ADDENDUM NO. 1
FRED MEIJER TRAIL HUB PHASE 1 CLEARING
401-751-977.851

January 19, 2023

FRED MEIJER TRAIL HUB
JACKSON'S LANDING AND AG DAVIS PARKS
LW22-0028
CITY OF GREENVILLE, MI

GRADING/SEC
PLAN
PART OF PHASE 1
& PHASE 3

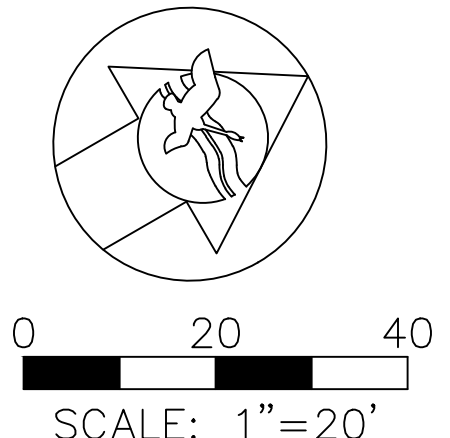
7. Is any clearing being proposed on the riverside of the Trail north of the building? *No.*
8. What about silt fence north of the building? *Silt fence is proposed for the area between the M-57 bridge and the Trail bridge. We expect that operations can be mitigated in the upland area without silt fence.*

9. Where is the silt fence shown? *Sheet 7 is included here to show the approximate location of the fence. It is intended to be between the bridges only even though it is shown to continue north of the Trail bridge.*
10. *An SESC permit will not be required for this work, but we still want the silt fence.*
11. *Placing chipped material over surface scarring from the clearing operation will be an acceptable form of stabilization.*
12. Is access to the site from the building and driveway at 502 E. Washington acceptable? *Yes, the property belongs to the City and is the intended access point for the work.*
13. Can chipped material be taken to the compost area along with the trees? *Yes.*

3. Is the intent for the clearing to go to the riverbank since the stakes are not on the bank? *The intent was to go to the riverbank, however a concern was brought up about the need to clear in order to set silt fence, which is a valid point. Therefore, the **scope is modified** to set the silt fence as directed by the Engineer and leave the brush and dead-fall along the riverbank in place.*
